DNO CNAIM V2.0 METHODOLOGY CHANGES EXPLAINED

CNAIM v2.0 Changes Explained

This document explains the differences applied in v2.0 compared to v1.1 in detail with the required explanation and justification behind the need for the changes including worked examples where necessary.

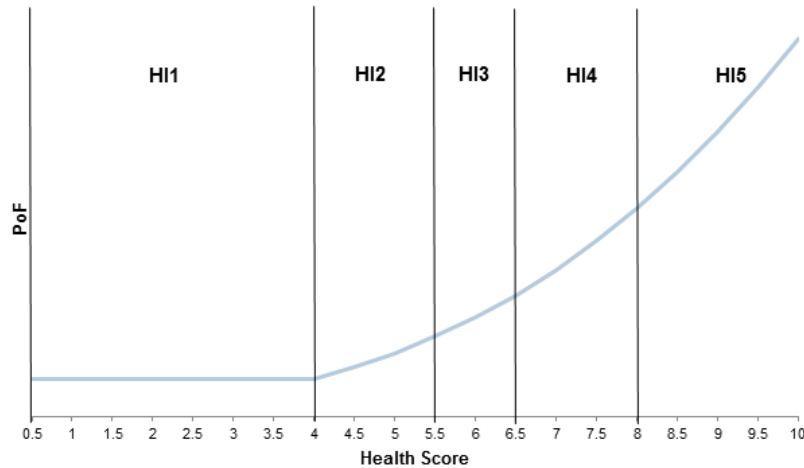
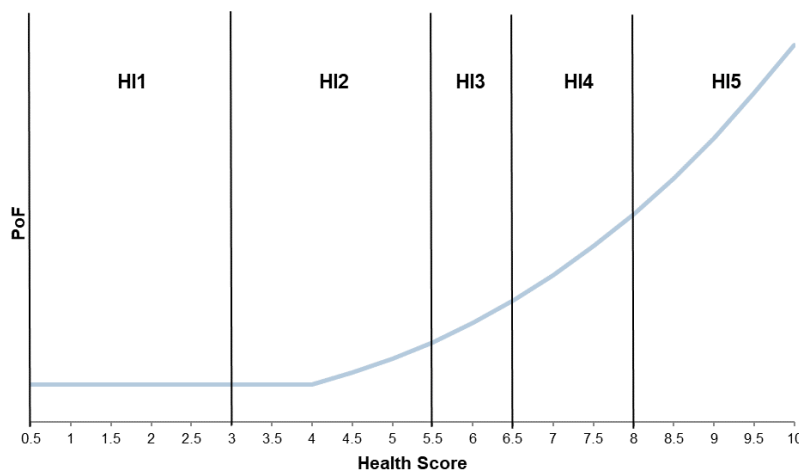
When the Health Index (HI) banding criteria was developed for CNAIM v1.1, the HI1 band was defined as being applicable to all assets where the Health Score is less than 4. This was appropriate because the same value of probability of failure (per annum) is given to all assets, within the same asset category, that have a Health Score of 4 or below. This also enabled the Risk Index for the HI1 band to be derived using a typical probability of failure that would be the same as the probability of failure that would be calculated individually for all assets included within the band.

used in the derivation of a Risk Index that considers Long Term Risk, may not be representative of assets at one or other end of the range of Health Scores within the band. For this reason, there is a need to revise the Health Index banding criteria for the HI1 band in CNAIM v2.0.

It is proposed to change the banding criteria for the HI1/ HI2 boundary in CNAIM v2.0 to a Health Score of 3. This is a reduction of the upper limit of the HI1 band, which was set at a Health Score of 4 in CNAIM v1.1.

Health Index Band	Health Index Banding Criteria	
	Lower Limit of Health Score	Upper Limit of Health Score
HI1	≥ 0.5	< 3
HI2	≥ 3	< 5.5
HI3	≥ 5.5	< 6.5
HI4	≥ 6.5	< 8
HI5	≥ 8	≤ 15

The figure below illustrates the revised banding criteria for CNAIM v2.0: -
